May 27, 2014

RE: Depleted Uranium Performance Assessment (DUPA) for the Clive Facility
Round 2 Interrogatories
DRC Radioactive Materials License 2300249

ROUND 2 INTERROGATORIES**

Figure 6.8 from NUREG/CR-7028 (Benson et al. 2011)

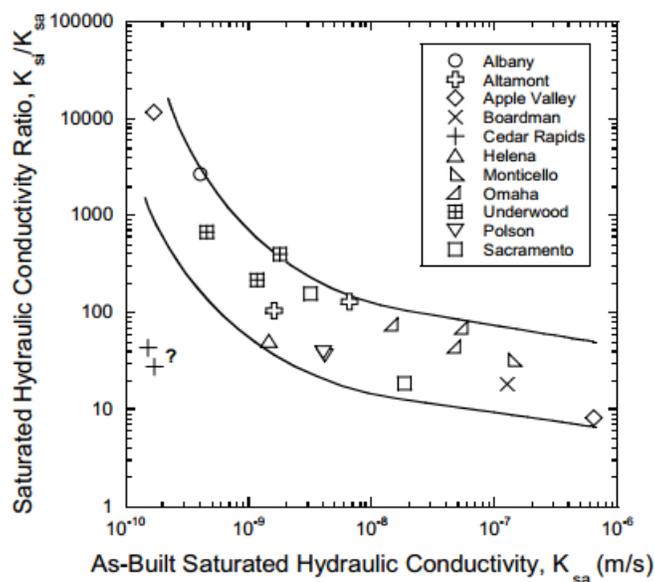
1. The ES response began by referring to two documents (EnergySolutions 2013b and EnergySolutions 2014), which obviously were not included in FRV1. ES needs to integrate the information from these two documents into the revised report. Then DRC can review and comment on how that information is being used in the DU PA.

2. The ES response indicates that the evapotranspirative (ET) cover would reduce infiltration by two orders of magnitude compared with the rock armor mulch cover. The revised GoldSim DU PA model (v1.199) provided by ES on May 5, 2014 (Rogers 2014), does not support this statement. The original mean infiltration rate (VerticalFlow_BelowCap) was about 0.12 cm/yr, whereas with the ET cover the rate is about 0.04 cm/yr—reduced by only a factor of three.

3. The ES response indicates that the ET cover design will limit infiltration down to the radon barrier. However, the response does not address what impact (if any) burrowing animals, plant roots, gullies, and similar mechanisms would have on the radon diffusion upwards to the surface.

Figure 1. E_H -activity diagram demonstrating uranium speciation and solubility in the absence of carbonate. Note yellow regions indicate formation of a solid phase. Model generated using Geochemist Workbench and LLNL v8r6+ database.

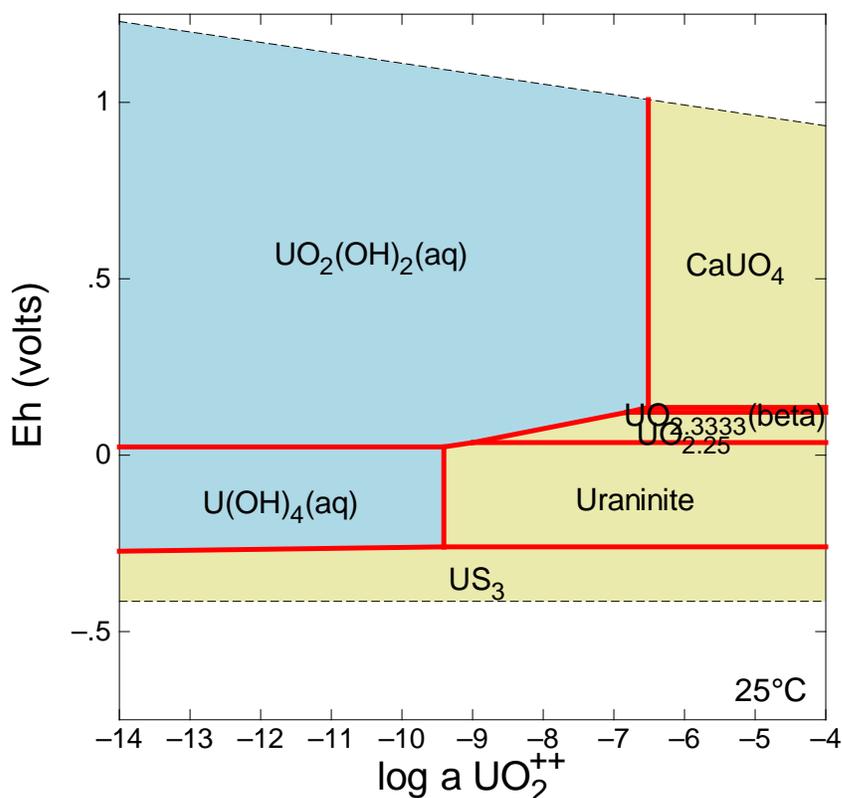
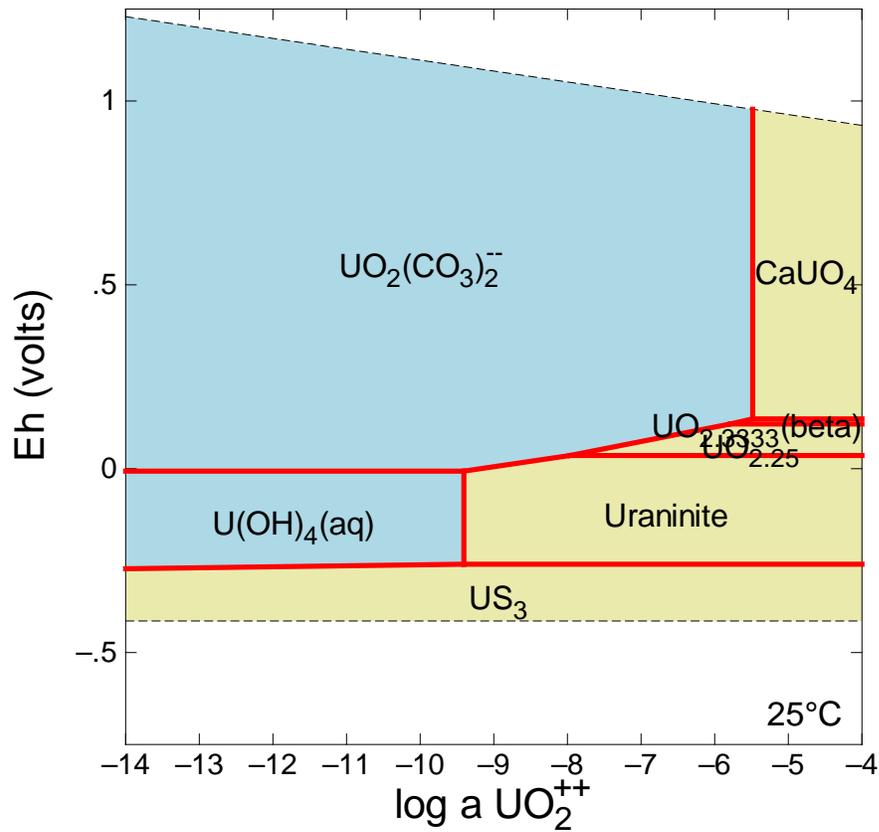
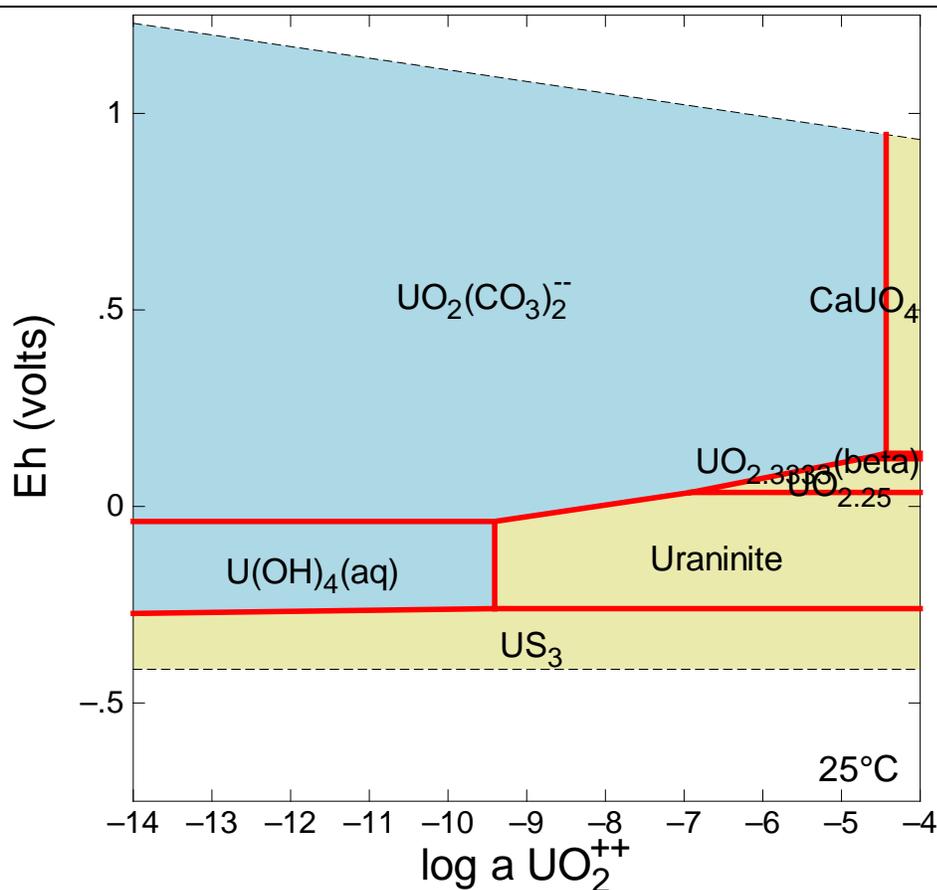
These solubility values are based on the assumption that these ions are dissolving from pure solutions. However, it is more likely that the ions are present as solid-solutions within the uranium solid phases. The PA should explain whether the differences between solubility of a pure phase versus that of a solid-solution have been considered in the models.

The phase diagrams in Figures 1–3 below were generated to illustrate the solubility of uranium versus redox potential in the presence and absence of carbonate using Geochemist Workbench with the Lawrence Livermore National Laboratory (LLNL) v8r6+ database. The diagrams were generated using the dissolved ion concentrations from Tables 5 and 6 in the Geochemical Modeling report (Appendix 6 to FRV1), with and without carbonate included and with the pH fixed at 7. The E_H and total uranium were varied, and the diagrams are shown in a pourbaix format with the dominant species shown in each region. Under reducing conditions, formation of U(IV) minerals limits the solubility of uranium through formation of uraninite.

The last line of Table 2-64/1 provided in the response presents uranium solubility data from SNL (2007). The uranium concentrations reported in Table 2-64/1 seem to only include the solubility of U(VI) phases and do not consider the potential formation of U(IV) phases, which will have significantly decreased solubility. The PA should indicate whether the geochemical model considers the potential formation of uraninite or other U(IV) phases and the expected redox conditions of the waste. Not considering the U(IV) phases if they are indeed forming will result in a very overly conservative estimate of aqueous uranium concentrations.

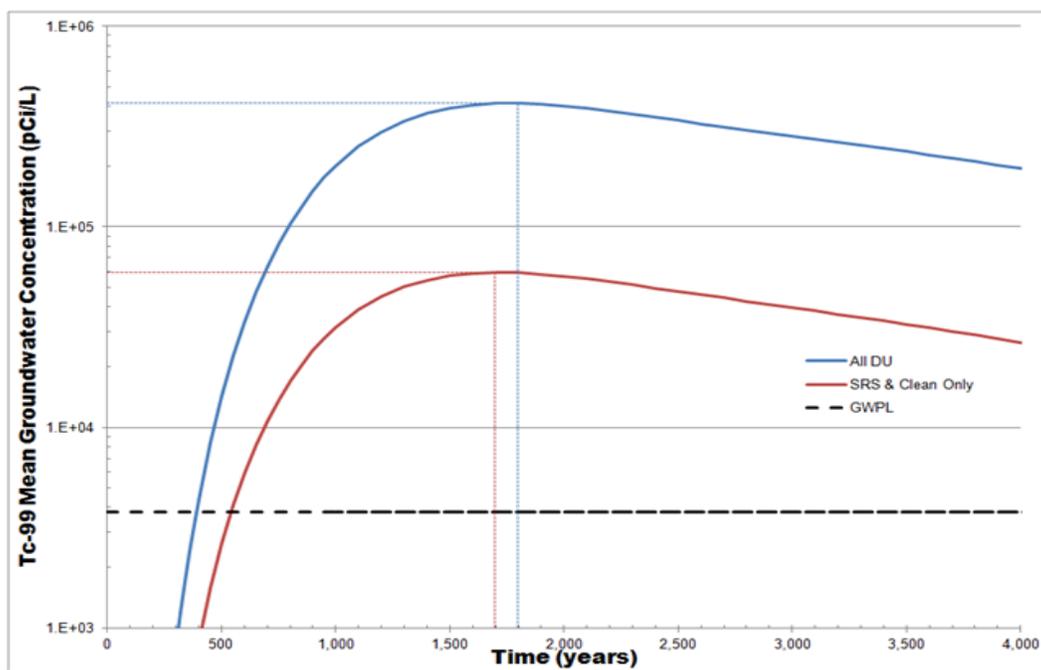
It is not clear that all of the groundwater protection criteria will be satisfied if the stated Tc-99 limits are imposed on the waste. According to Table 5 of the Waste Inventory report, the PA assumes that the mean Tc-99 content is 23,800 pCi/g. This model input waste source term concentration appears to need additional justification and possible revision, as noted in other interrogatories. Section 2.5, page 2-12, of the 2013 Compliance Report, Revision 1, indicates that the DU waste is to be buried at 10 meters. In this case, FRV1 Table 2 shows a peak mean for Tc-99 of 14,400 pCi/L, which is significantly above the GWPL of 3,790 pCi/L.

The figure below shows SC&A’s GoldSim simulations comparing Tc-99 concentrations against the GWPL. One case indicates that the Tc-99 GWPL is exceeded after 390 years. We also ran a case where the only source of Tc-99 was the DUO₃ from SRS and determined that the Tc-99 GWPL would be exceeded after 539 years. In another simulation, we decreased the infiltration rate to 0.09 cm/yr (Whetstone 2012, Section 2.4.1) and determined that the Tc-99 GWPL was exceeded in 494 years. Note that none of SC&A’s simulations demonstrated that shallow Clive groundwater quality would be protected, below the Tc-99 GWPL, for at least 10,000 years. Based on FRV1 Table 2 and our simulations, it appears that Tc-99 will not meet the established GWPL if the DU is buried at 10 meters.

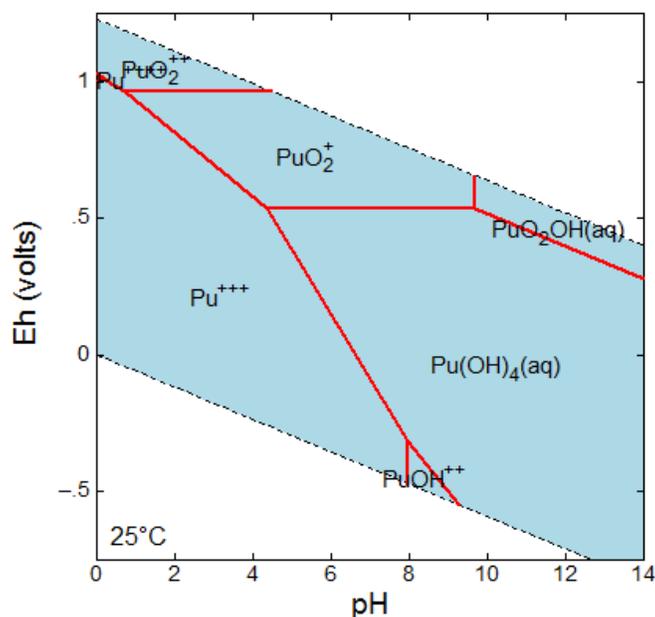
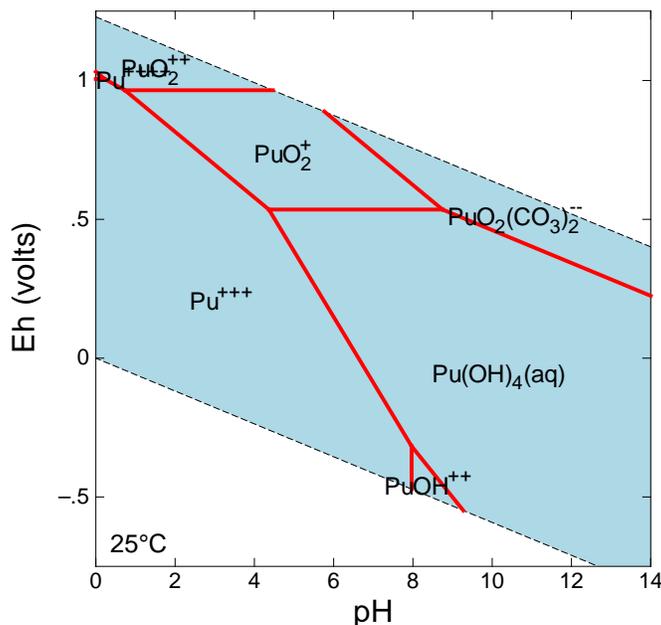
Section 4.1.7, page 13, of the Geochemical Modeling report states that “*Plutonium can be found in a number of valence states under the conditions at Clive. The most likely states are as Pu(V) and Pu(VI) both as cations and complexed with hydroxide and carbonate.*”

The specific data or model used to verify the statement should be provided. The simple Eh-pH figure below, generated from our own modeling, and many similar ones that can be found in the

EPA (1999) indicates that soil redox conditions are not as important as ligand presence and concentration, as well as carbonate ion concentrations (Section 5.6.6.1). There is some discrepancy between EPA (1999) Figure 5.3, which indicates $Pu(OH)_2(CO_3)_2^-$ would be the dominant Pu solution species, and the figures above, generated using Geochemist Workbench.

Fig. 1. Profile of cover used at Monticello Disposal Facility. The cover prolife above the geomembrane constitutes the water balance cover

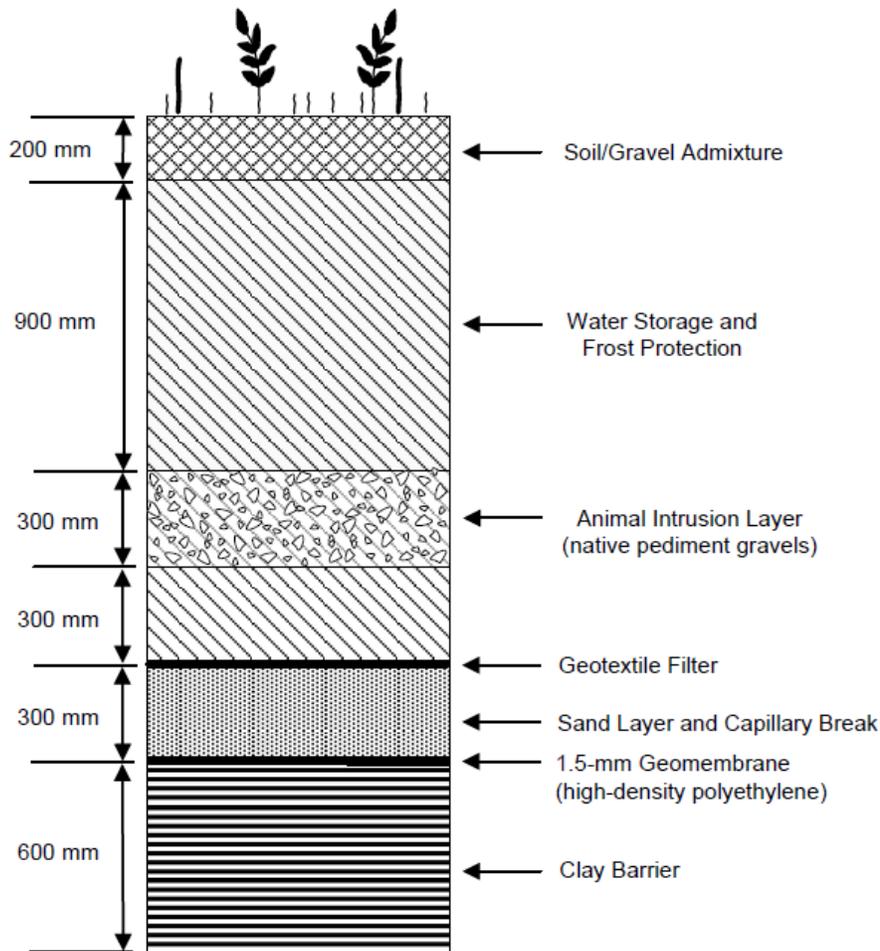
Figure 1 (Benson et al. 2008) and Figure 2 (Bareither and Benson 2013) show the cover profiles at these sites. Both sites employ large-scale volumetric lysimeters based on the design developed in the Alternative Cover Assessment Program, as described in Benson et al. (2001) and Albright et al. (2010). The Cheney site has two replicate lysimeters, labeled C and R. Percolation rates measured at these sites are summarized in Table 1 (Monticello) and Table 2 (Cheney) (DOE 2012, DOE 2013). The lysimeters at Monticello and Cheney are at 2% grade, similar to the top deck of the Federal Cell.

The average percolation rate for the water balance cover at Monticello is 0.5 mm/yr, which is about 25 times higher than the percolation rate predicted for the water balance cover for the Federal Cell. Monticello is in a wetter climate, which can increase the percolation rate, but Monticello also uses a much thicker storage layer (Figure 1) than the cover proposed for the Federal Cell, which will reduce the percolation rate. Thus, the very low percolation rate predicted for the Federal Cell needs additional justification.

Fig. 2. Profile of rock armor cover used at Cheney Disposal Facility.

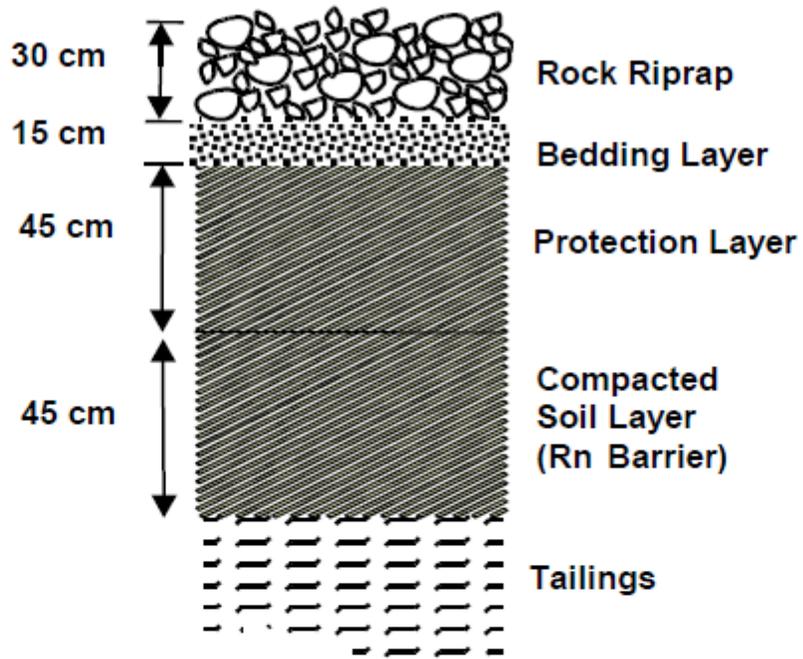
rate is more than two times the average percolation rate predicted for the rock armor cover for the Federal Cell as reported in EnergySolutions (2012) (pp. 3-7 and 3-8), even though the average precipitation at Cheney has been lower than the average precipitation cited for the Federal Cell. The significance of this difference in percolation rates needs clarification.
